ARM Group Inc.

January 24, 2018

Re: Response and Development Work Plan
Sub-Parcel B6-2 (Revision 1)
Responses to Agency Comments
Tradepoint Atlantic
Sparrows Point, MD 21219

Figure
3

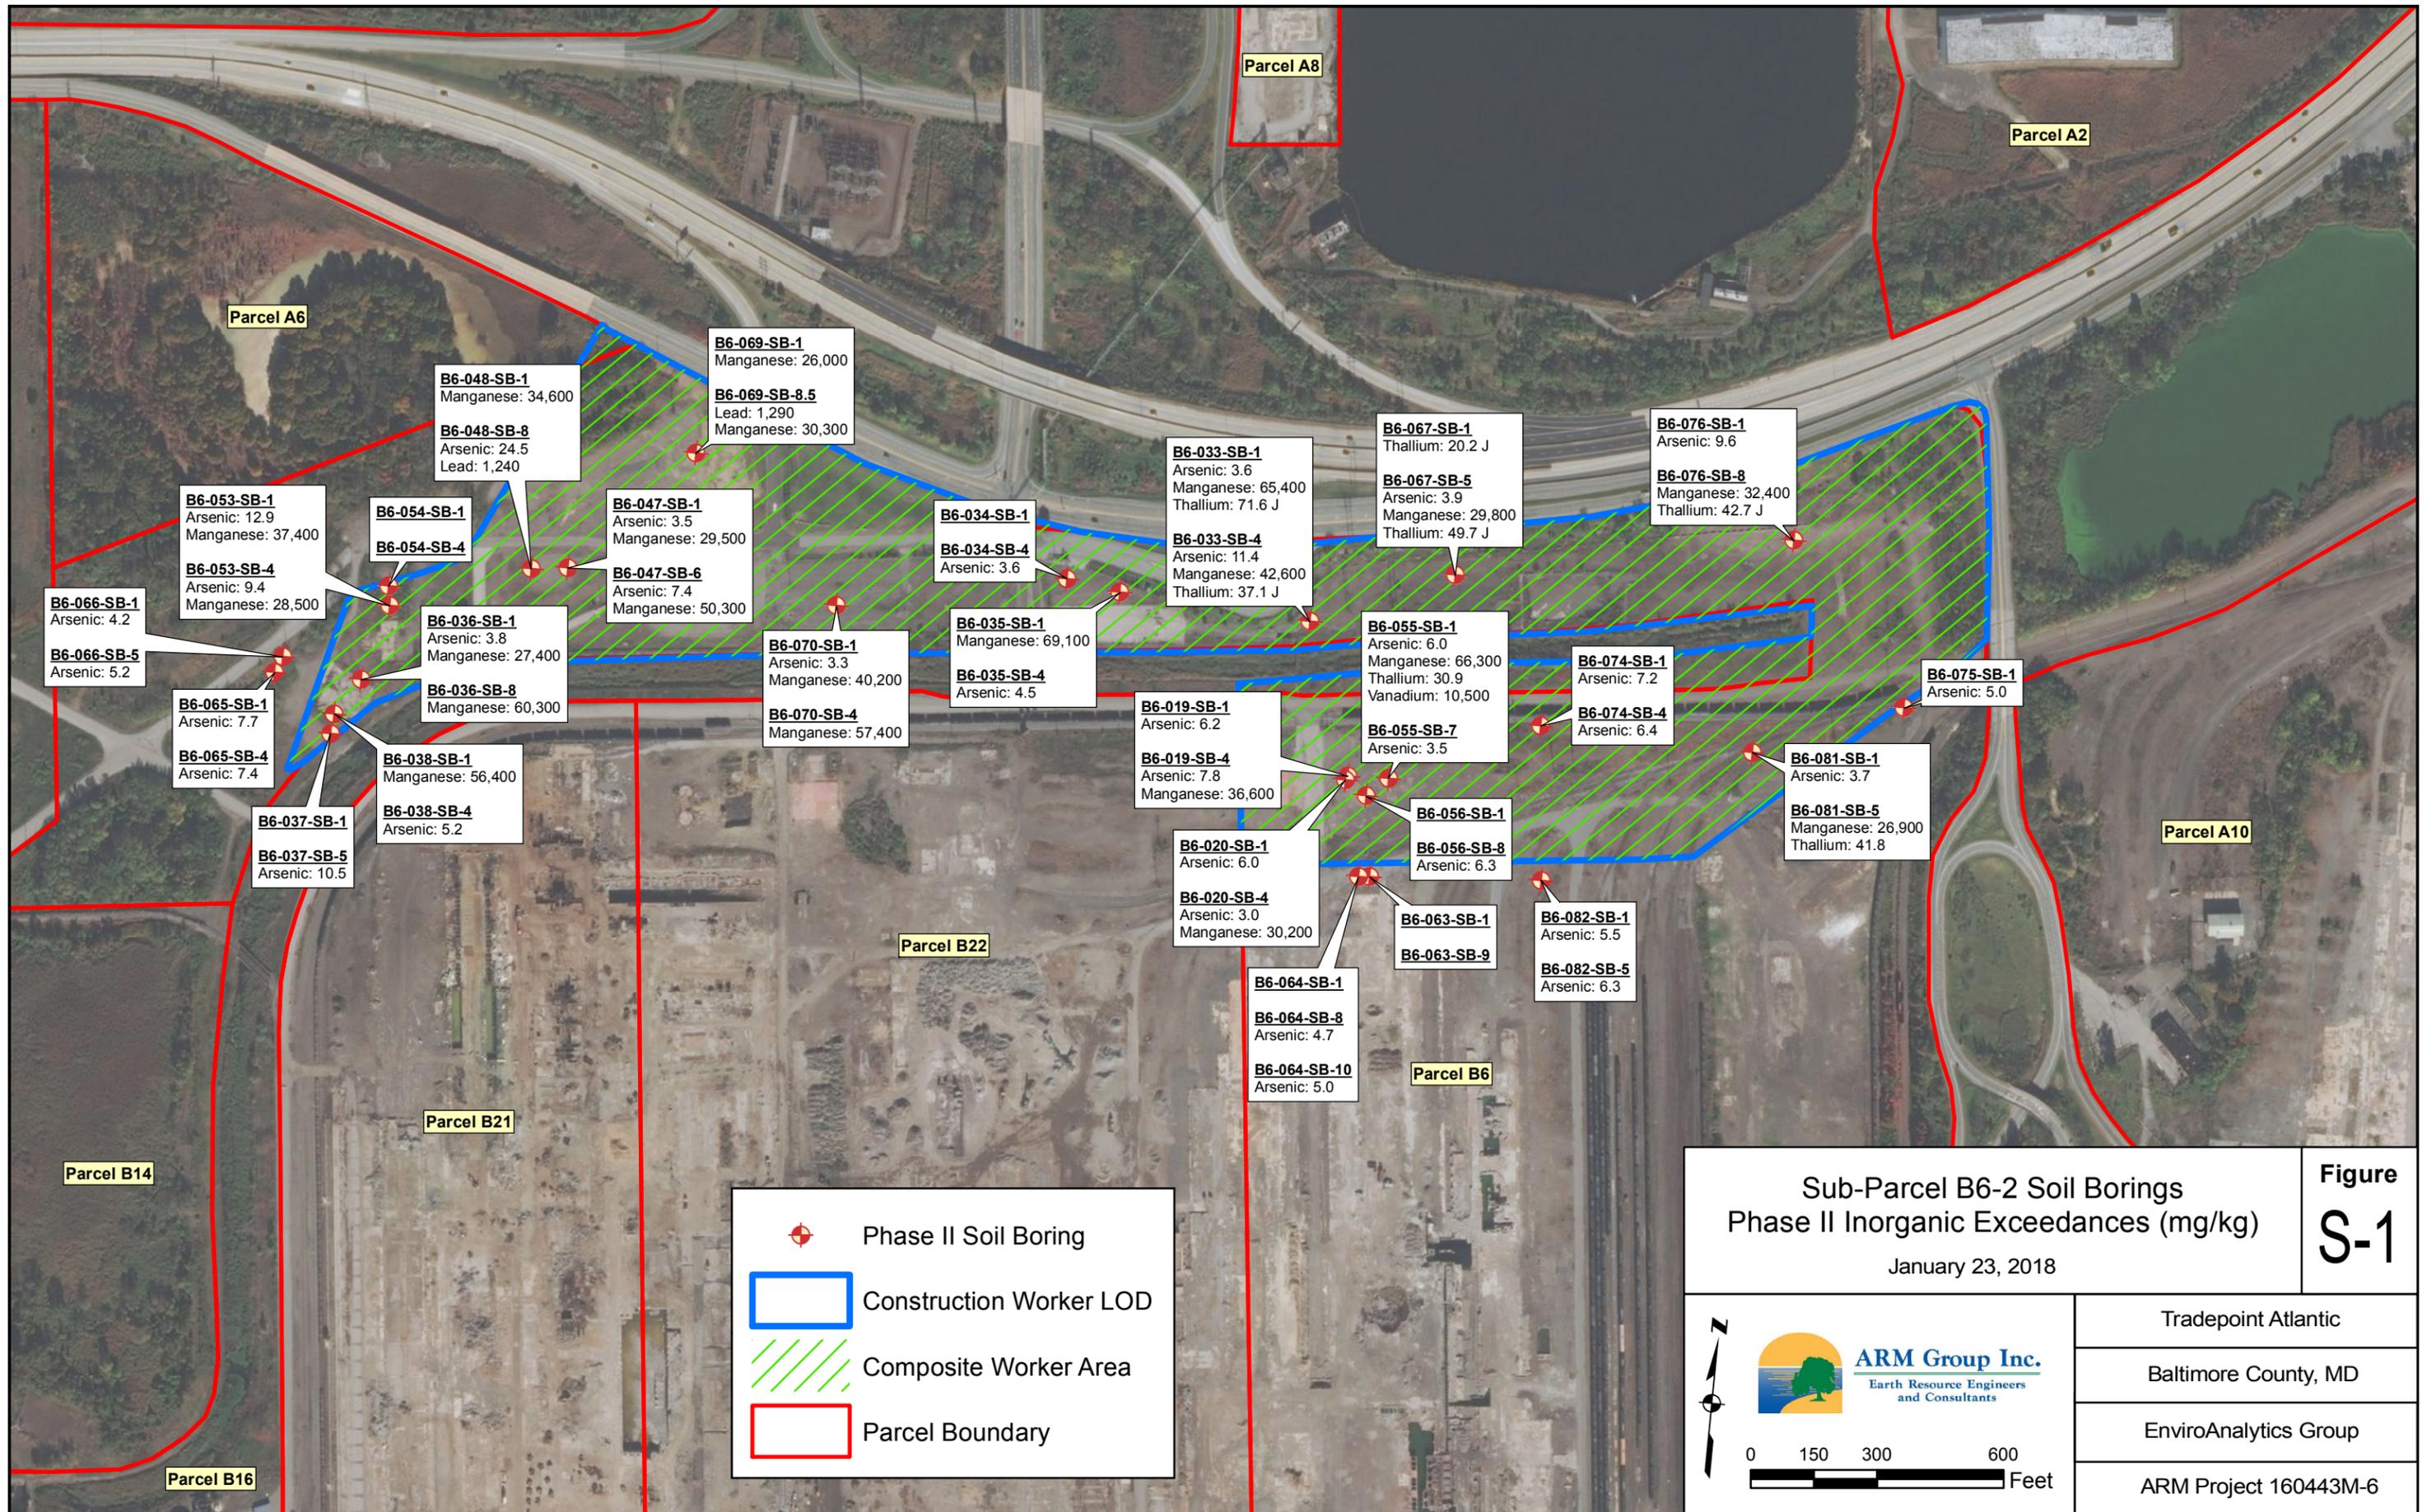
1. *Section 3.5.1, Analysis Process and Figure 3 – Only A4-016, A4-014, and B6-068 sample results were excluded from the composite worker area EPCs; however, the B6-063 to B6-066 locations and B6-082 location are also outside the composite worker area, but were included. Presumably this is because they are considered proximate enough to the composite worker area to retain; however, this is not discussed in the text. Revise to include.*

Locations A4-016-SB, A4-014-SB, and B6-068-SB were located along a utility easement to the west of the retail area, as shown on **Figure 3** of the previous submission of the RADWP. Therefore, the analytical results from these borings were considered to be relevant for evaluating potential Construction Worker risks during utility trenching, but not Composite Worker risks because this easement was not going to be developed further or occupied as part of the retail area. Based on development plans recently provided by Tradepoint Atlantic, the utility to the west of the retail area has been eliminated. Instead, the utility will be tied into a sewer system proposed to the east of the retail area (to be completed outside of the scope covered by this RADWP). This rerouting of the utility is also addressed in item #10b, below. Excluding **Figure 1**, all remaining figures in the RADWP have been revised to show the new limit of disturbance (LOD) for the Construction Worker and/or revised development drawing basemaps (provided in the revised **Appendix E**). The Composite Worker Area remains unchanged; the Construction Worker LOD and Composite Worker Area now match.

Since the western utility easement will be eliminated, boring locations A4-016-SB, A4-014-SB, and B6-068-SB are no longer relevant for the proposed development, and were eliminated from the RADWP and all applicable figures and tables. **Table 1, Table 2, Table 5, and Table 6** were revised to remove the data associated with these soil samples. All figures showing these boring locations were revised. In addition, the Construction Worker Exposure Point Concentrations (EPCs) were updated in the risk assessment tables (**Table 7 through Table 10**). The EPCs now match between the Construction Worker and Composite Worker because the same soil data is included in each scenario. **Appendix B** and the risk tables were also revised with the new Construction Worker Soil Screening Levels (SSLs) to account for the revised area of the construction LOD (50.5 acres). Since the RADWP also included a discussion of groundwater data obtained along the western utility easement (now excluded), the groundwater analytical results from A4-013-PZ and A4-014-PZ were eliminated from **Table 3 and Table 4**, and all relevant figures were revised to remove these locations.

Figure
8

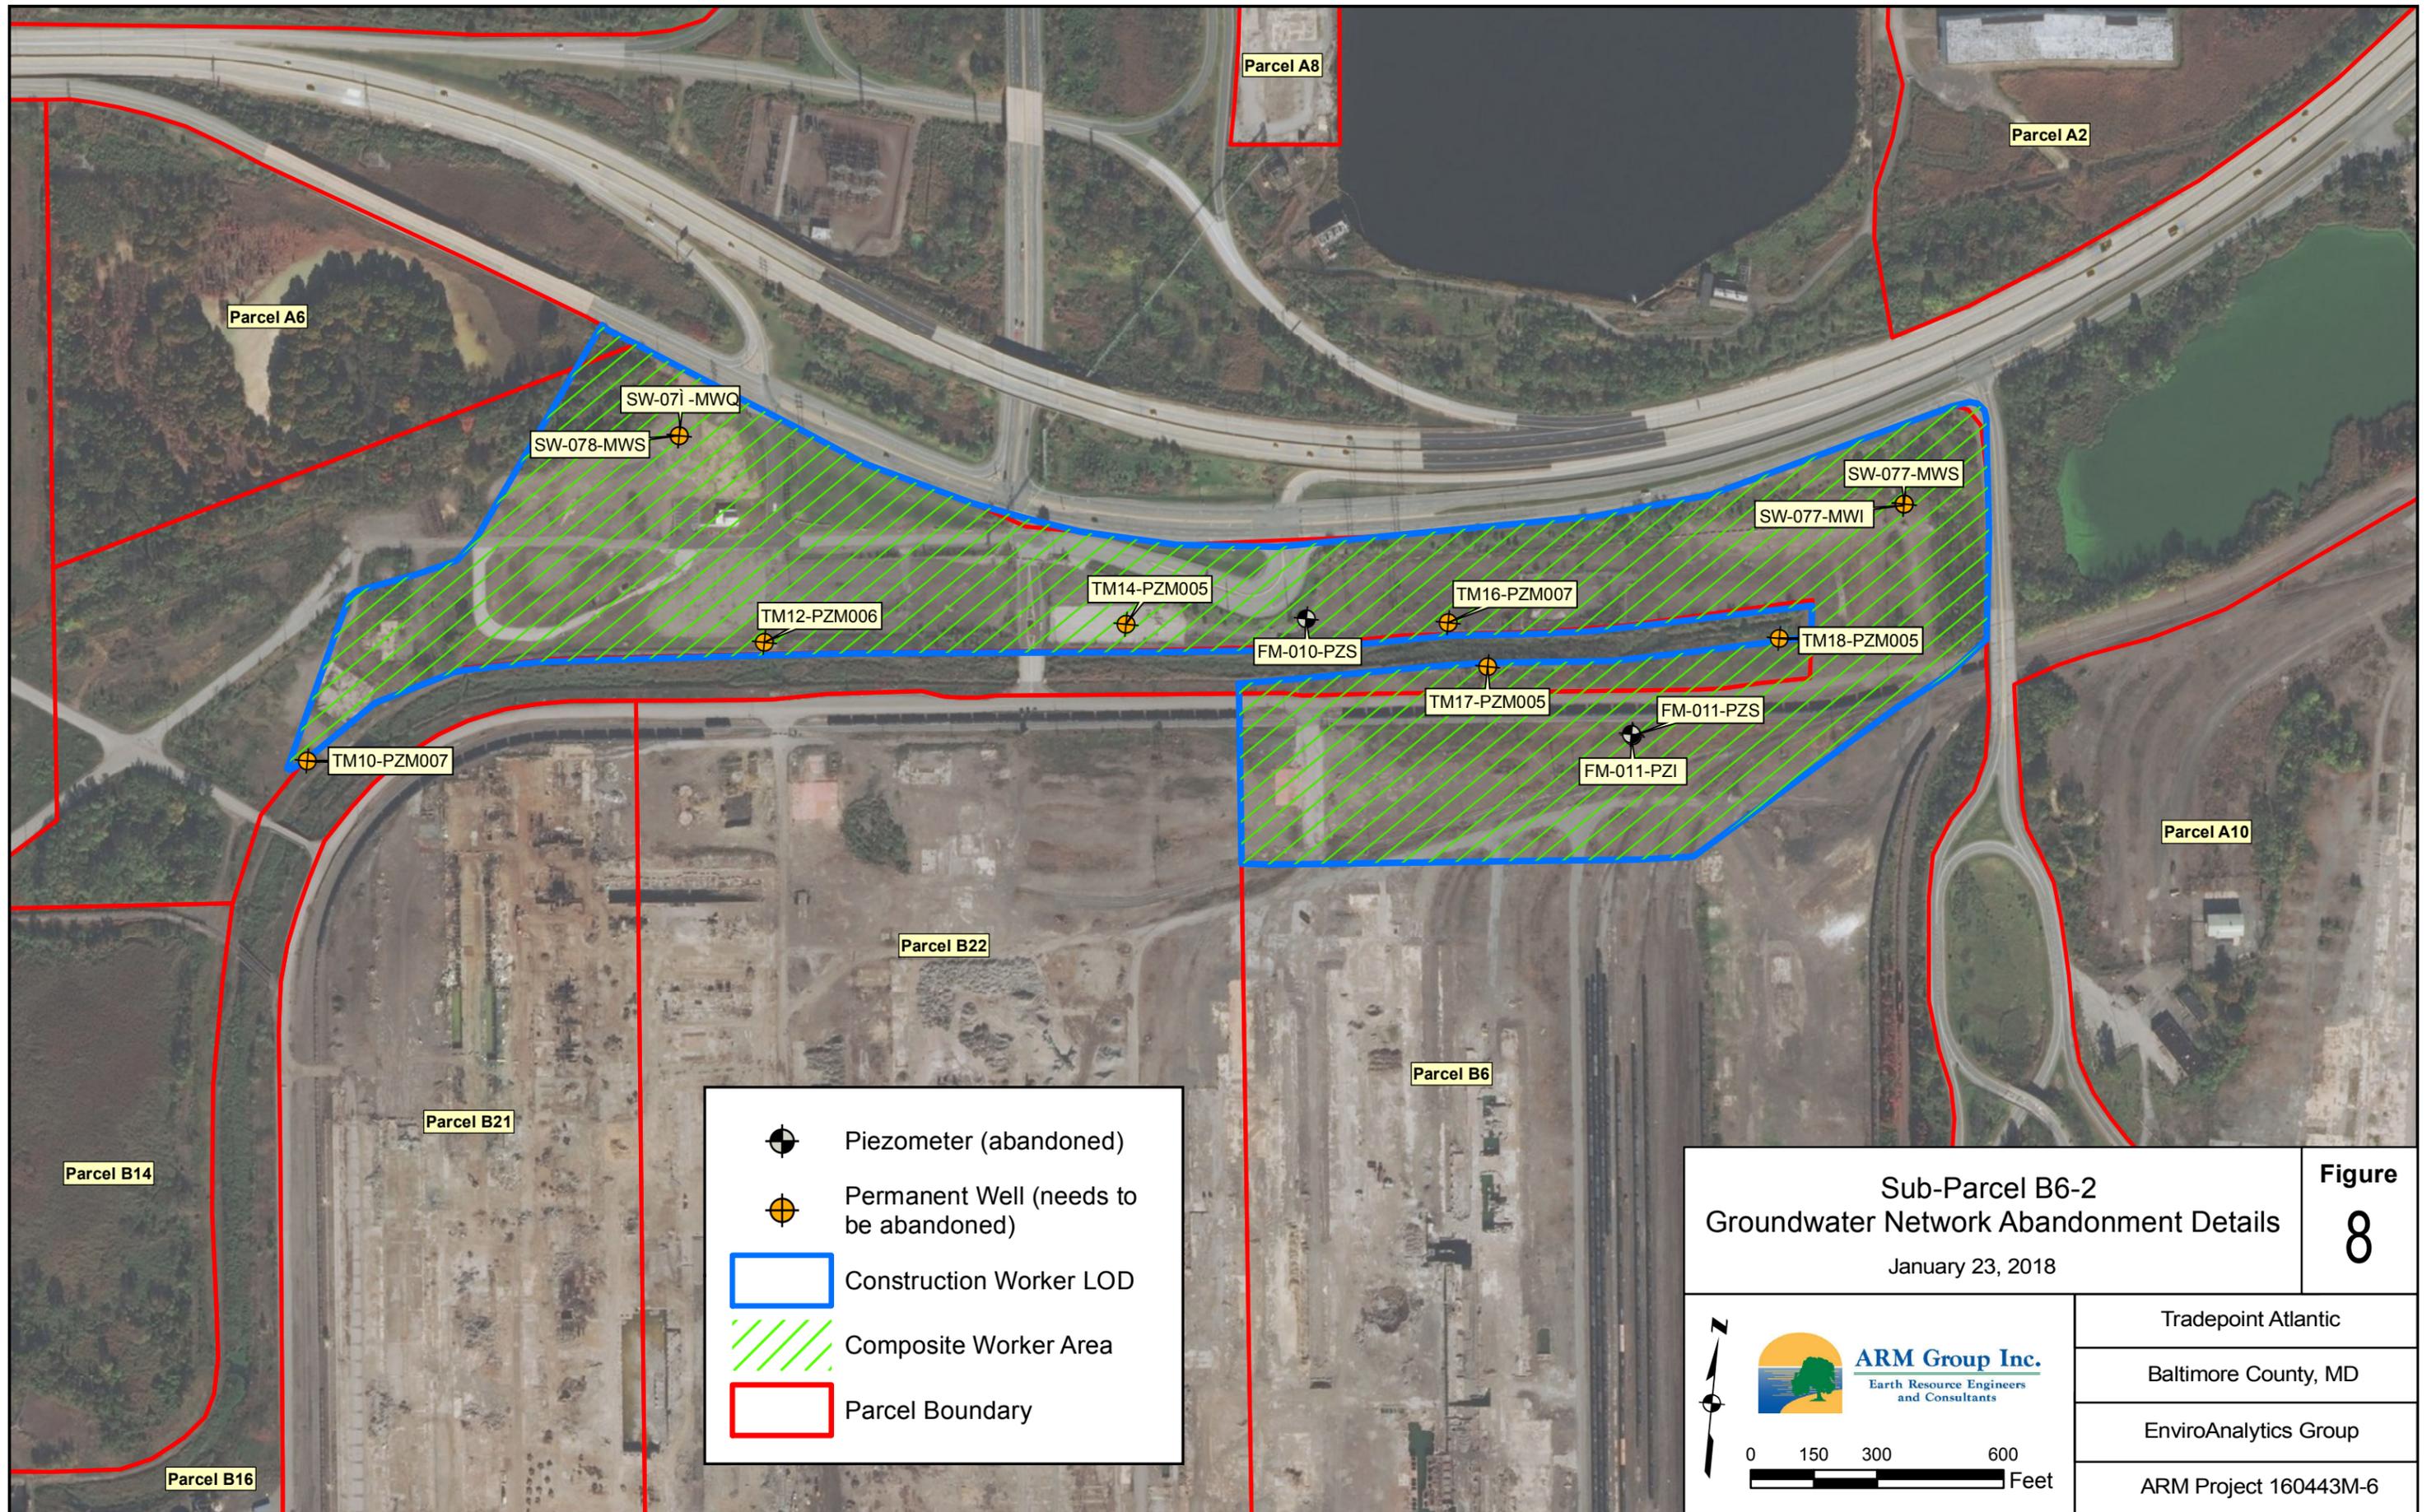
5. *Section 4.0, Proposed Site Development Plan, Response Phase, Groundwater Network Abandonment Plan, p. 25-26 –*

- a. The discussion summarizing the Finishing Mills Groundwater Phase II Investigation Report is confusing because all applicable values (such as the chronic criteria) are not included. This section should be revised to include all of the relevant data discussed.*

Figure 8 shows the permanent wells and temporary groundwater sample collection points relevant for Sub-Parcel B6-2, and indicates the wells that are proposed to be abandoned. The NAPL screening piezometer B6-056-PZ will also be abandoned (and gauged a final time on the abandonment date). As stated above, the temporary groundwater sample collection points in the Finishing Mills Area have already been abandoned.
